**8.2 R GORRY - RECONFIGURING A LOT - SUBDIVISION (1 INTO 6 LOTS) - LOT 1 ON SP218094 - 12 BARNWELL ROAD, KURANDA - RAL/23/0003****Date Prepared:** 10 July 2023**Author:** Planning Officer**Attachments:**  
1. Proposal Plan  
2. Submissions**APPLICATION DETAILS**

APPLICATION		PREMISES	
APPLICANT	R Gorry	ADDRESS	12 Barnwell Road, Kuranda
DATE LODGED	9 March 2023	RPD	Lot 1 on SP218094
TYPE OF APPROVAL	Development Permit		
PROPOSED DEVELOPMENT	Reconfiguring a Lot – Subdivision (1 into 6 Lots)		
FILE NO	RAL/23/0003	AREA	7.9652 ha
LODGED BY	Scope Town Planning	OWNER	R Gorry
PLANNING SCHEME	Mareeba Shire Council Planning Scheme 2016		
ZONE	Rural Residential		
LEVEL OF ASSESSMENT	Impact Assessment		
SUBMISSIONS	17 Submissions

Figure 1: Proposed Site Plan (Scope Town Planning).

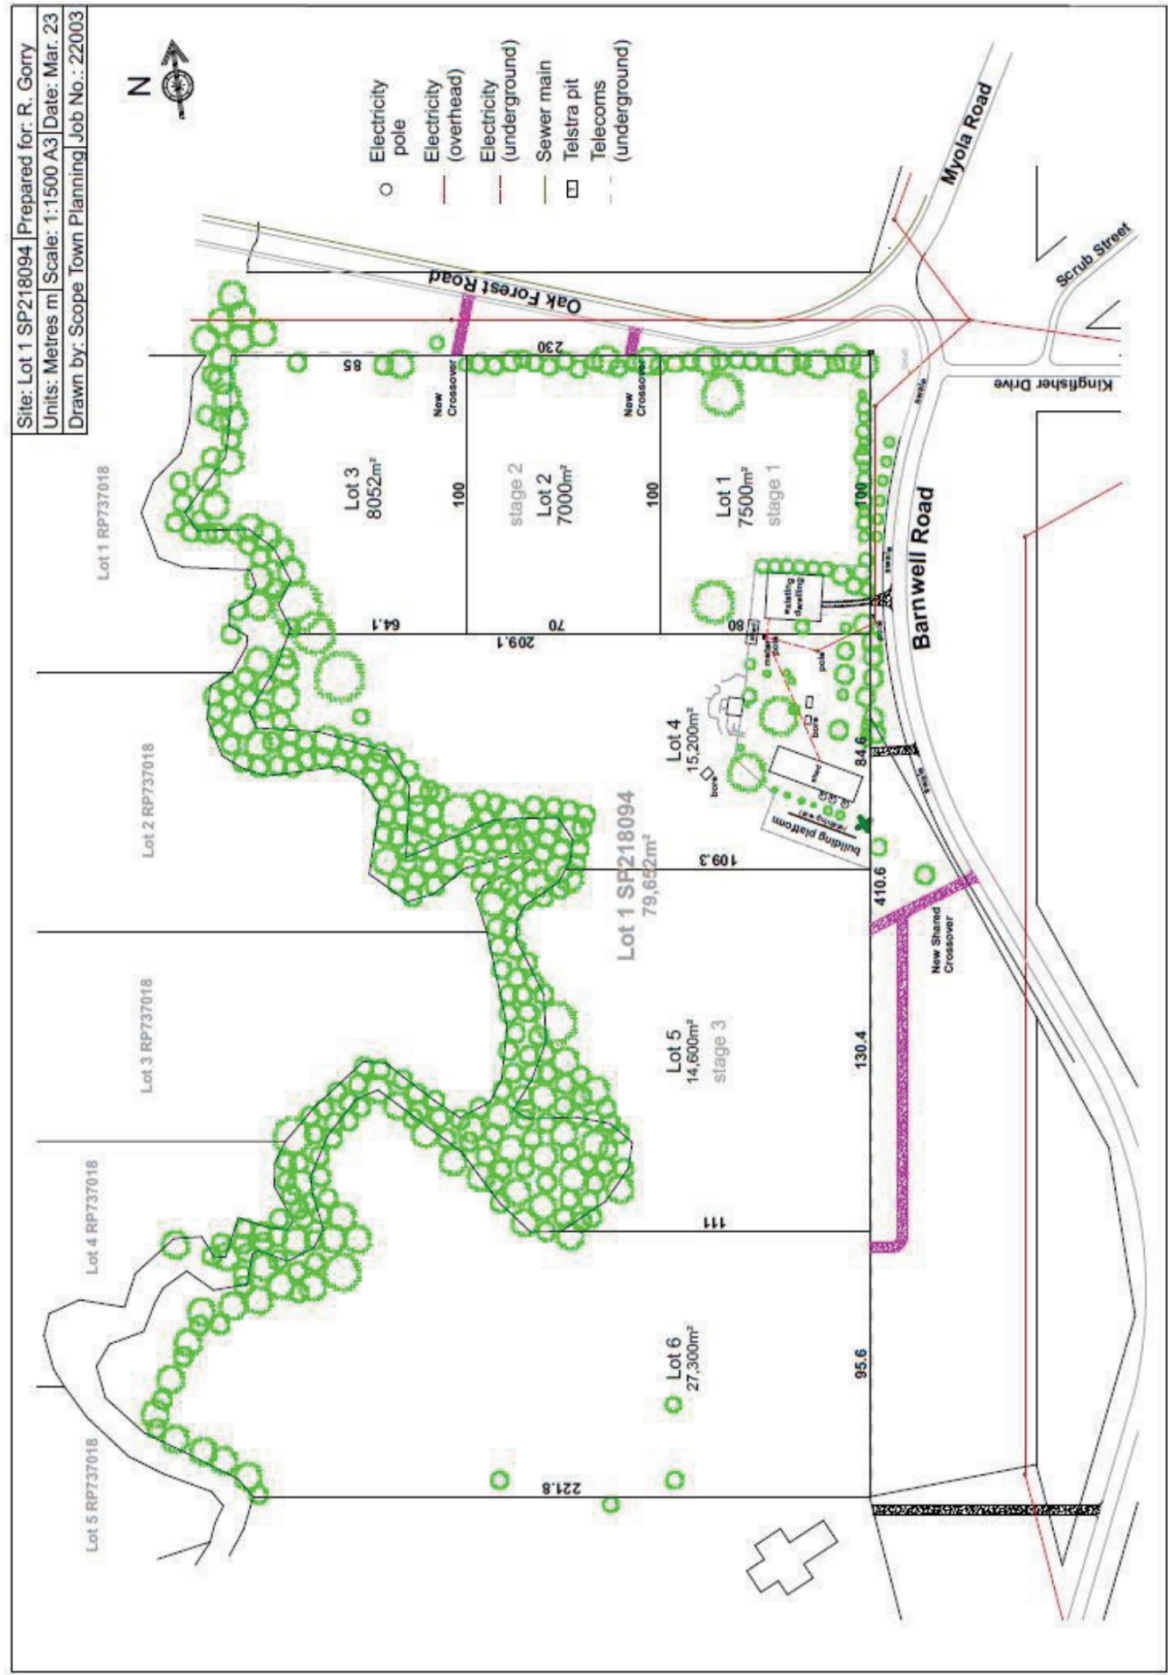
Grounds for objection /support	Comment
Proposed Lots 1, 2 and 3 are inconsistent in size with the average lot size in the surrounding rural residential area. The application should be amended to reduce the number of proposed Lots to 4 to ensure each lot is approximately 2 hectares in size consistent with the surrounding lot arrangement.	Noted – This issue is discussed throughout the body of the report. Council officers have recommended that the application be approved in part only, allowing the creation of only 4 lots. These 4 lots will be consistent in size to existing rural residential lots in the immediate area.
Proposing new lots such as Lots 2 and 3 so close to Cain Creek will have a detrimental environmental impact on both Cain Creeks water quality as well as the riparian vegetation.	Noted – Council officers have recommended that the application be approved in part only, allowing the creation of only 4 lots. Proposed Lots 1, 2 and 3 will be amalgamated to form a single allotment.

lot will be smaller than 1.5 hectares which is generally consistent with existing lots in the surrounding rural residential area.
All lots should be accessed via Barnwell Road and not Oak Forest Road.	Noted – This will be achieved.
Lots 1, 2 and 3 are within the mapped bushfire hazard area (buffer).	Noted – Council officers have recommended that the application be approved in part only, allowing the creation of only 4 lots. Proposed Lots 1, 2 and 3 will be amalgamated to form a single allotment which contains an existing dwelling, therefore there will not be any change to the number of dwellings situated in the bushfire hazard area.
The small residential lots located to the north-east of the site along Myola Road and Scrub Street should not be used as precedent to approve smaller proposed Lots 1, 2 and 3.	Noted - Council officers have recommended that the application be approved in part only, allowing the creation of only 4 lots. Proposed Lots 1, 2 and 3 will be amalgamated to form a single allotment.

Proposed Lots 1, 2 and 3 essentially fall within the Rural residential “4,000m <sup>2</sup> precinct” these lots do not have access to town water and should not be created.	Noted - Council officers have recommended that the application be approved in part only, allowing the creation of only 4 lots. Proposed Lots 1, 2 and 3 will be amalgamated to form a single allotment.
The application does not include a stormwater quality management plan required for any development on land greater than 2,500m <sup>2</sup> or that would result in the creation of 5 or more lots or 5 or more dwellings.	Council officers do not believe that a stormwater management plan or a stormwater quality management plan are warranted in this instance given the type and scale of development recommended for approval (4 lots only) as well as the topography of the site which each lot draining naturally into Cain Creek to the west of the building envelope areas.

Item	Note	Solution
Planning Scheme	Rural Residential C - 2 Hectare Precinct	Reduce to 4 lots for Precinct C
Settlement Pattern	Lot 1, 2, 3 are not within the settlement pattern size, eg. adjoining Monaro, High Chapparral	Reduce to 4 lots for Precinct C
Threatened Species Habitat Protections and Local Corridors	Cains (Cairns) Creek, Stream Order 2 (Table 8.2.4.3B - Setback and buffer distances from waterways)	Vegetation buffered from high bank to 25m, Cain Creek and buffer retained as "Environmental Reserve" not sold as Freehold
New driveways on Myola Road	Main commuter road access for residents in Myola, Mantaka, Kowrowa, Green Forest, Oak Forest, Russett Park, Mona Mona	No new driveways on Myola Road. All access to new lots from Barnwell Road only.
340m contour (flood) line	Land below 340m not suitable for structures or permanent use, proposed Lot 1 is 75% underwater.	Reduce to 4 lots for Precinct C

- (A) APPROVED DEVELOPMENT: **In Part Only** – Development Permit for Reconfiguring a Lot – Subdivision (**1 into 4 Lots only**)

1. This development permit authorises the subdivision of the site into **4 Lots only. Lots 1, 2 and 3 depicted on the approved plan must be amalgamated to form 1 single allotment.** The extent and location of lot boundaries for the 4 approved lots may vary subject to any alterations:

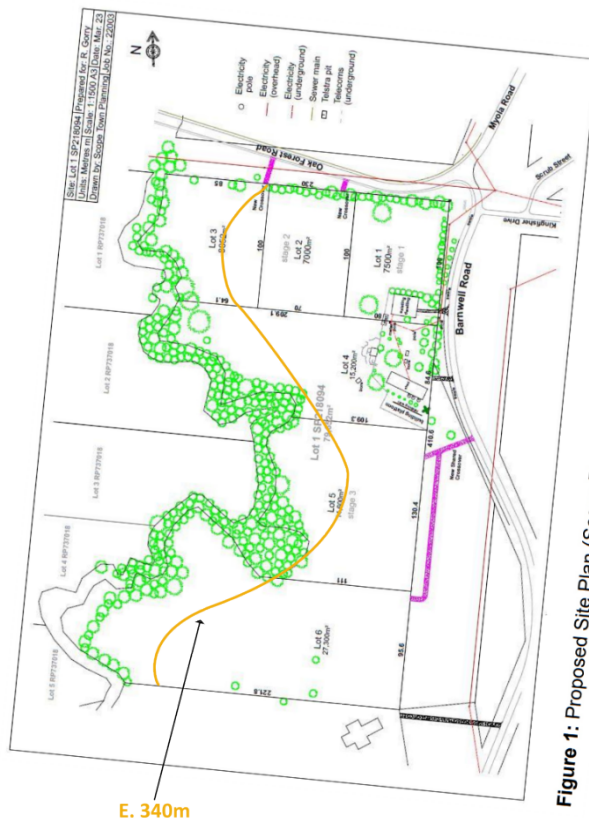
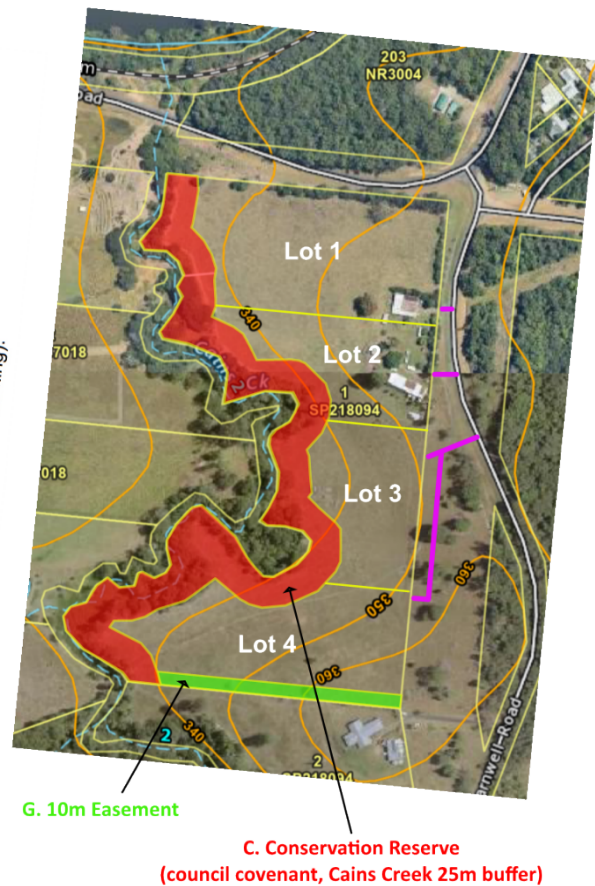
In closing we object strongly to the largely reduced lot sizes proposed within the plan of reconfiguration. While proposed Lots 4 through 6 present manageable ongoing impacts (provision of onsite services, impact upon the receiving environment and rural residential amenity), proposed Lots 1 through 3 are not considered appropriate in any way. As adjoining landowners, we foresee great impacts upon many elements of amenity, safety and preservation that will yield inconsistent and unwarranted development. We submit that the design of the reconfiguration is completely inappropriate and the application should be refused as it is contrary to the Planning Scheme's intent for the land.
